Project Name: Willow - Bid Package 2 – New Build

Project No.: 221125-090

Architect: Kingscott

This Addendum is issued to inform the bidders of modifications in the scope of work being bid for this project.

- SEE SHEETS S0.01-S0.04 FOR STRUCTURAL NOTES AND TYPICAL DETAILS
- GENERAL CONTRACTOR SHALL FIELD VERIFY ALL DIMENSIONS AND EXISTING CONDITIONS PRIOR TO CONSTRUCTION

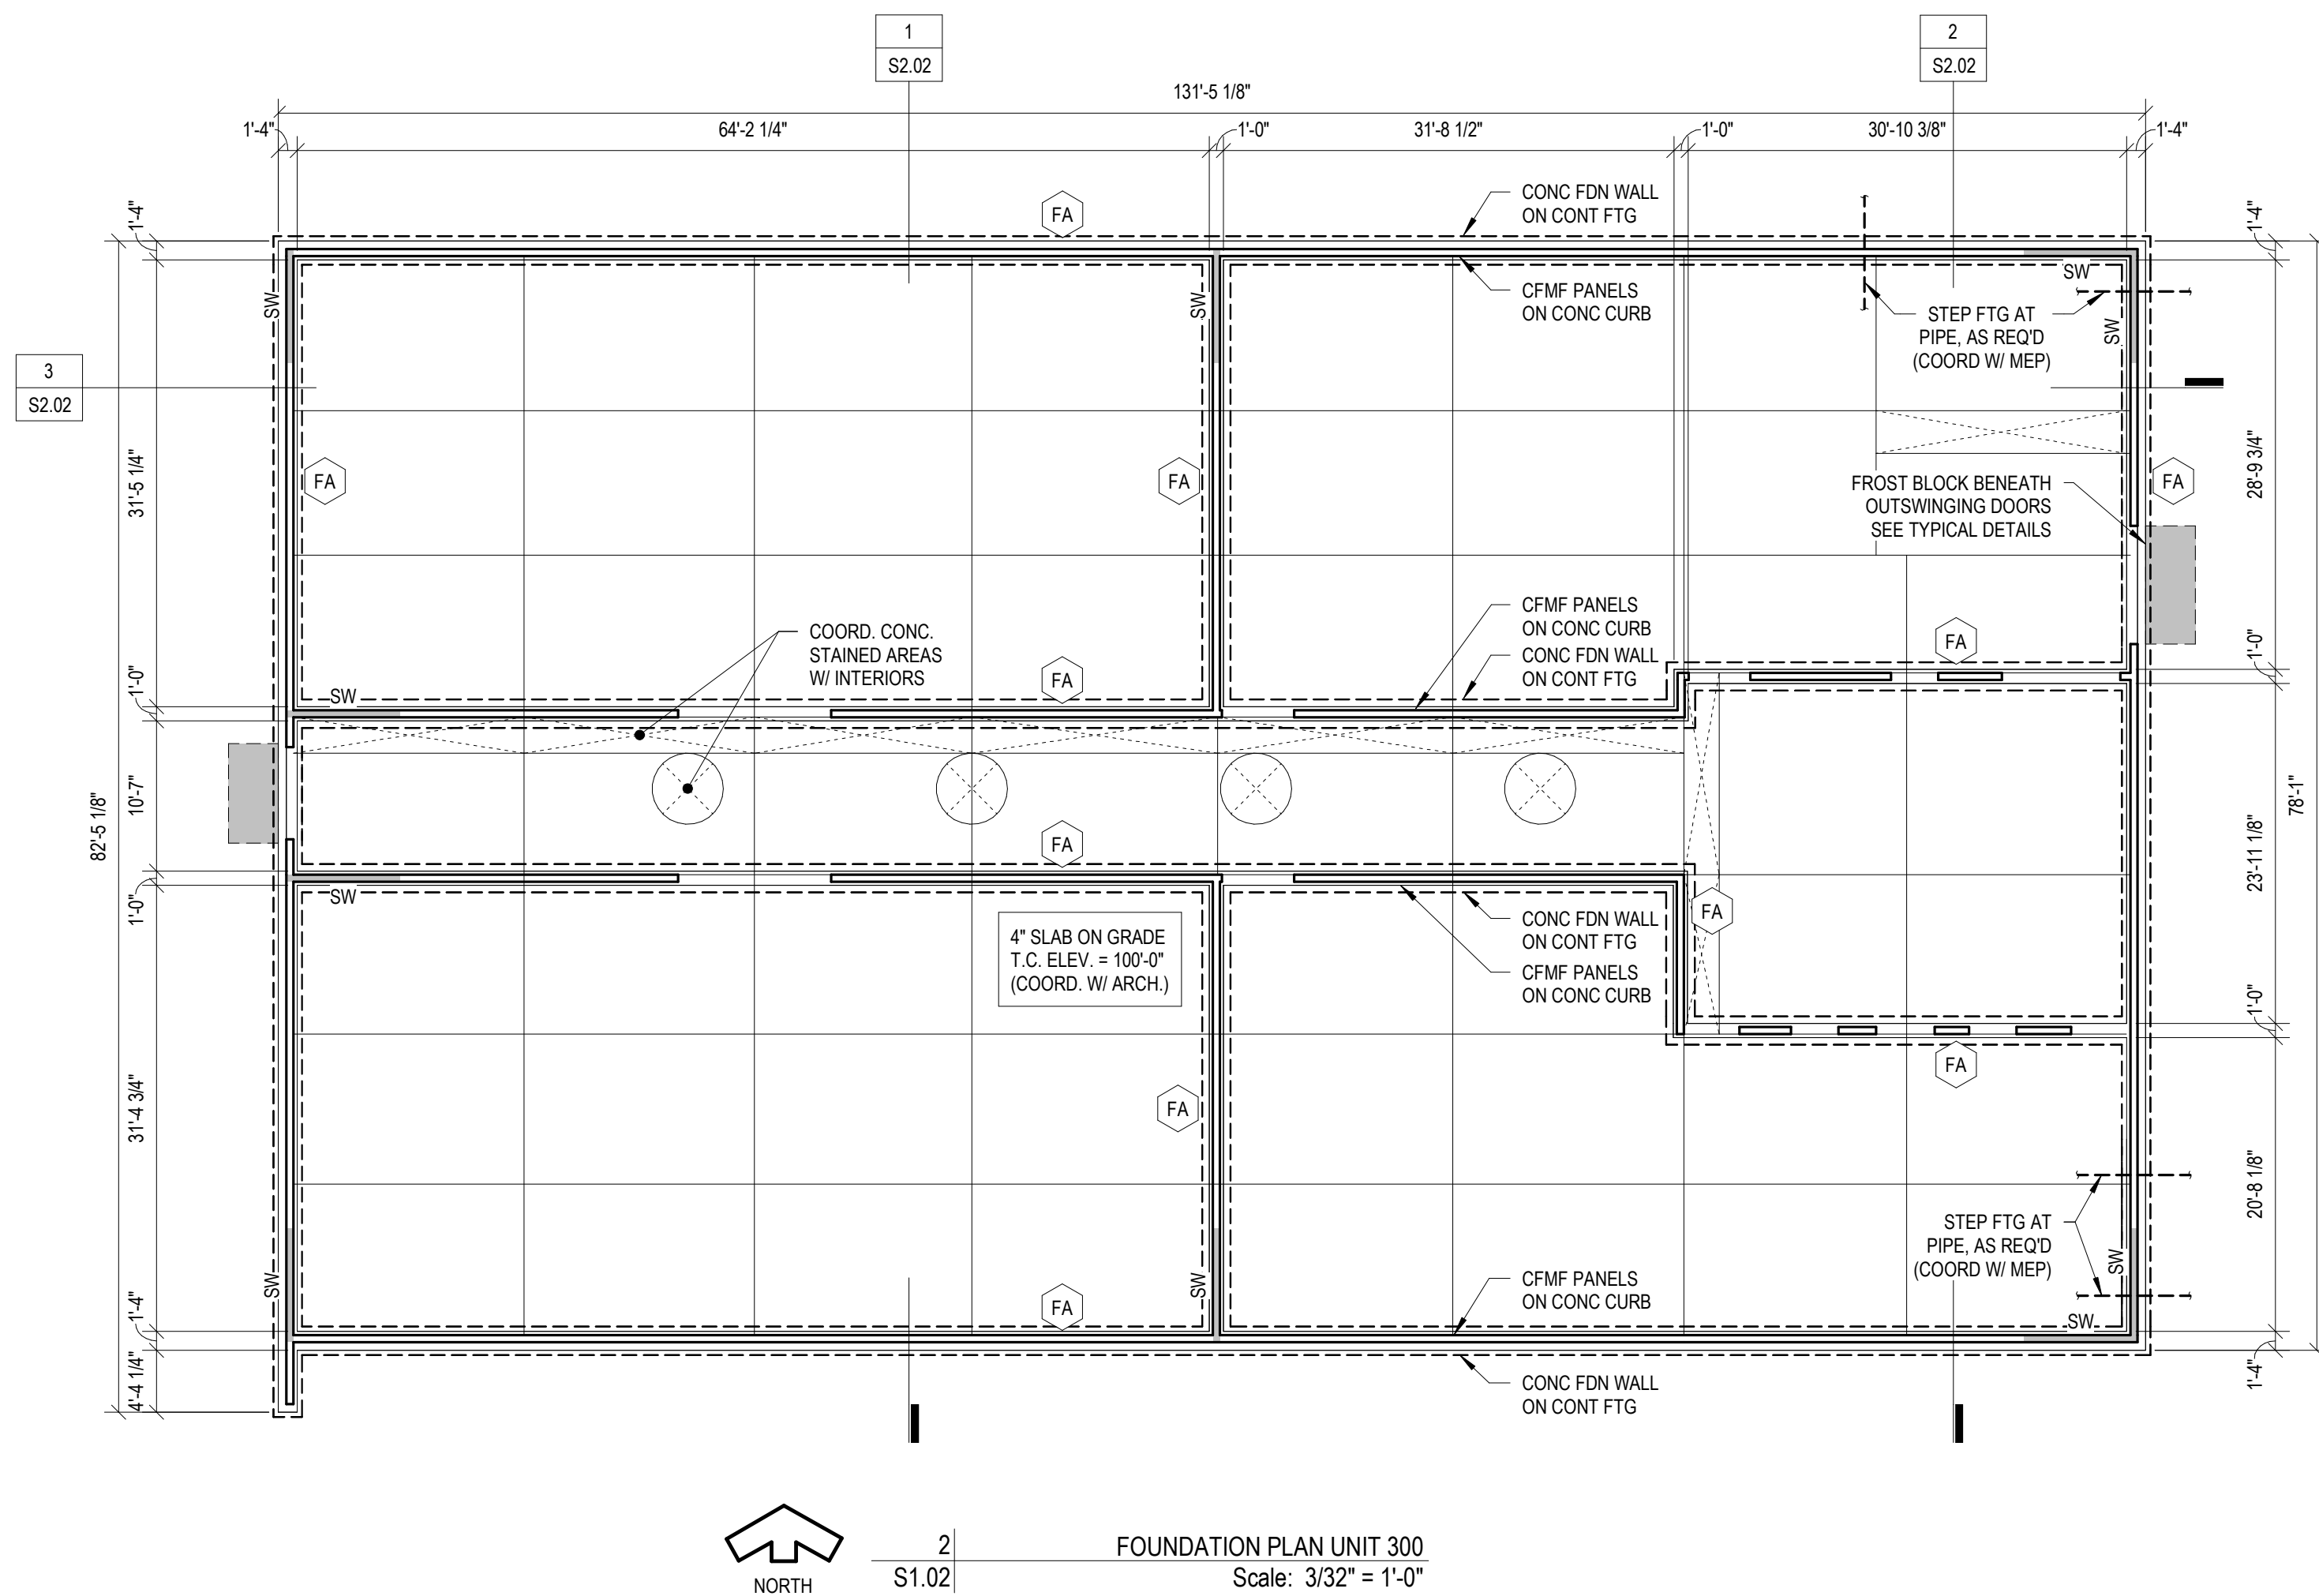
- Revised footing schedule “F5” to be top and bottom each way, hooked ends.

SHEET NO. **A0.4**

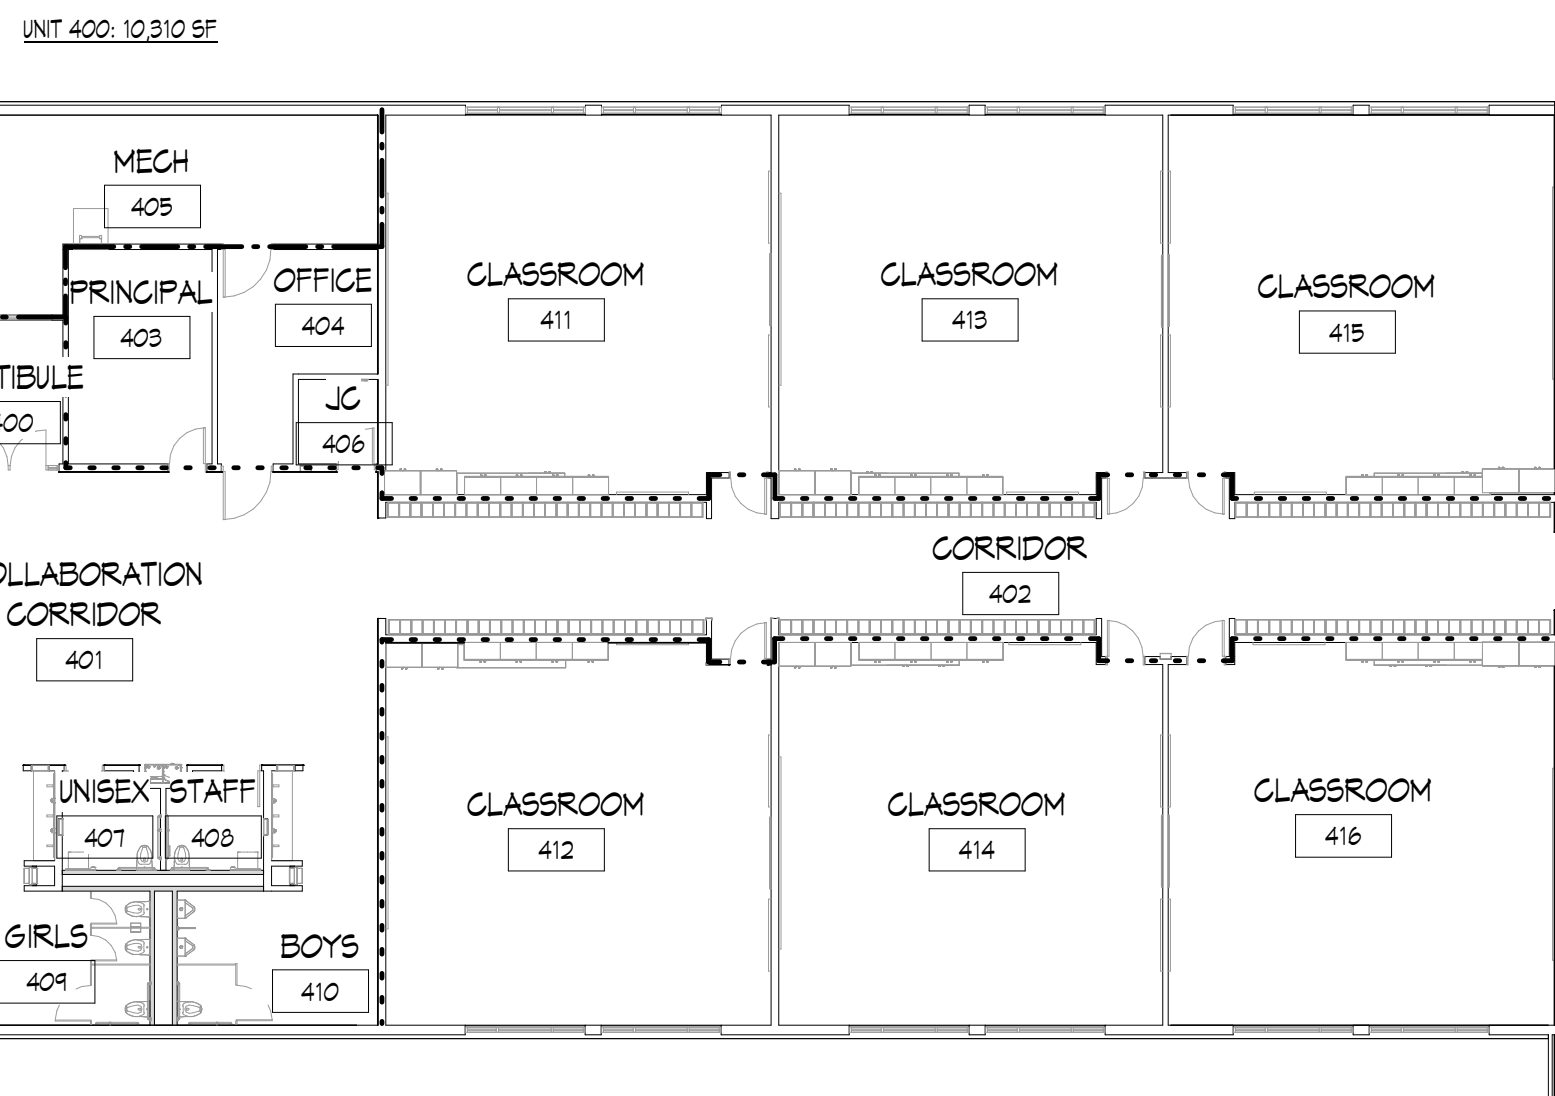
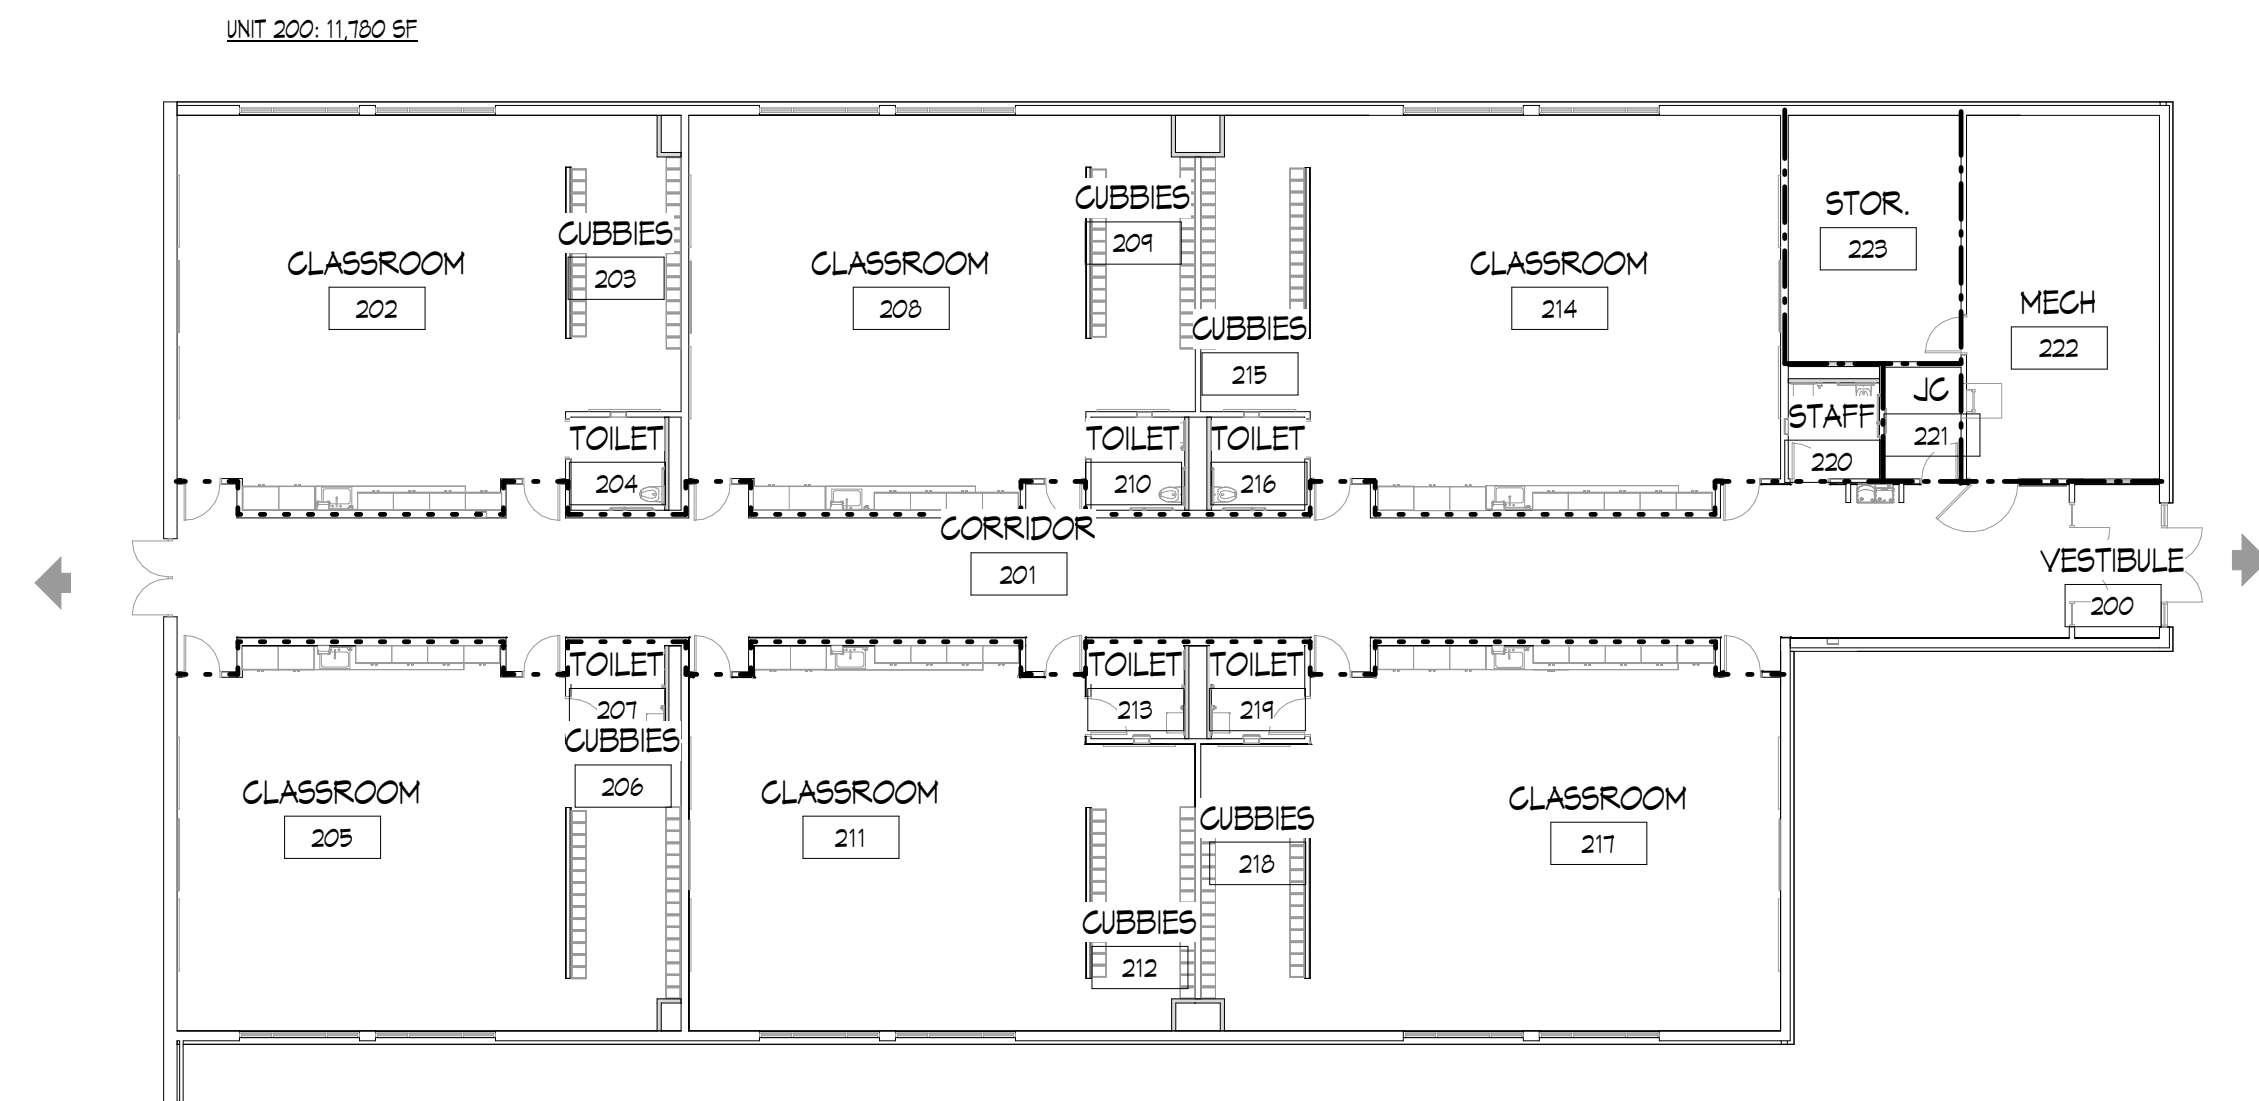
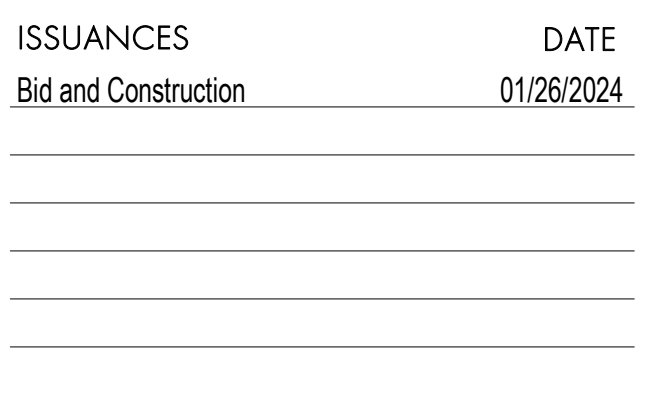
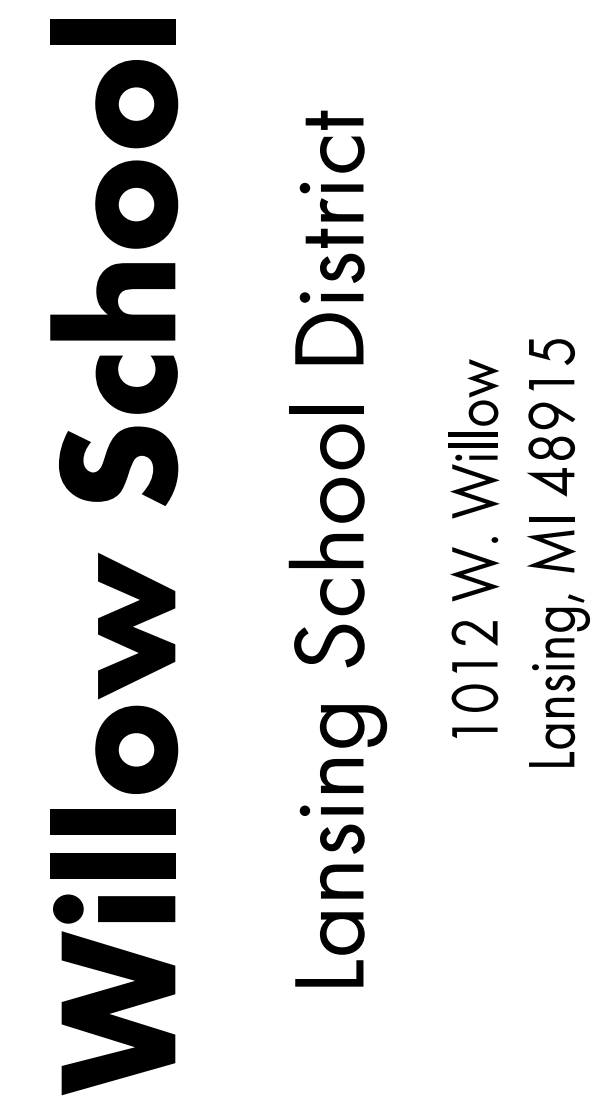
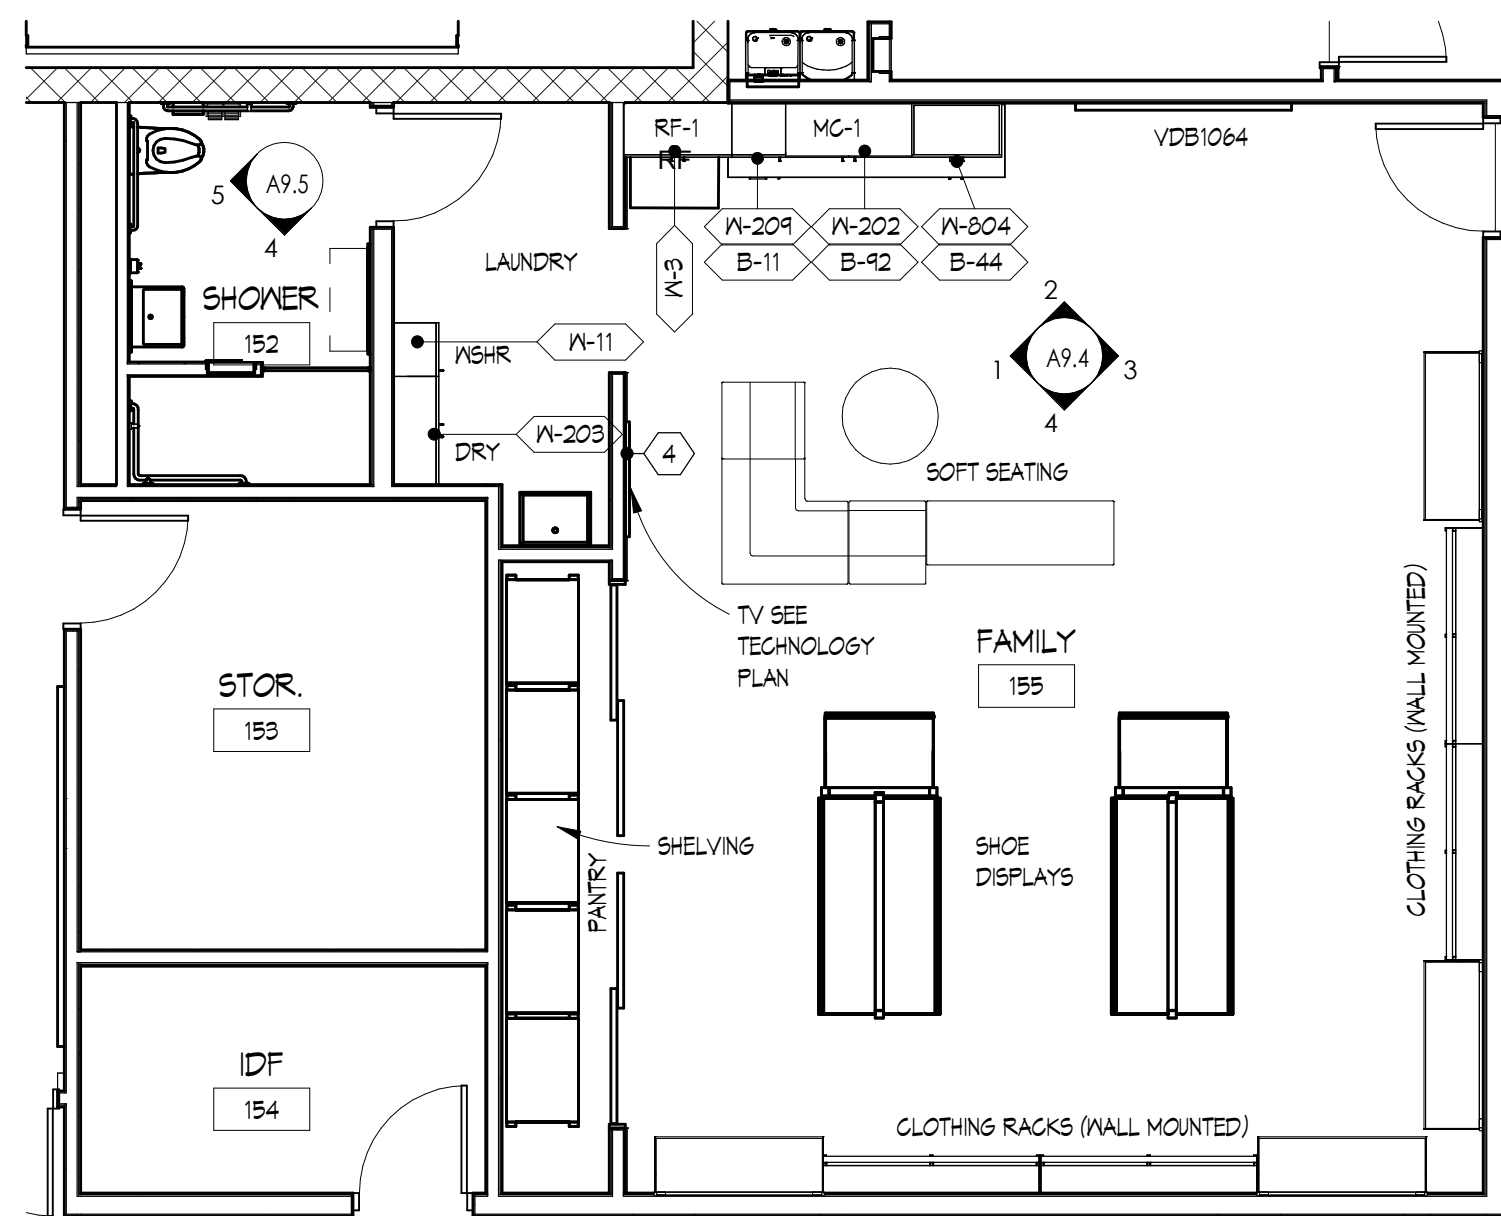
- Modified Code Compliance Legend to include missing text.
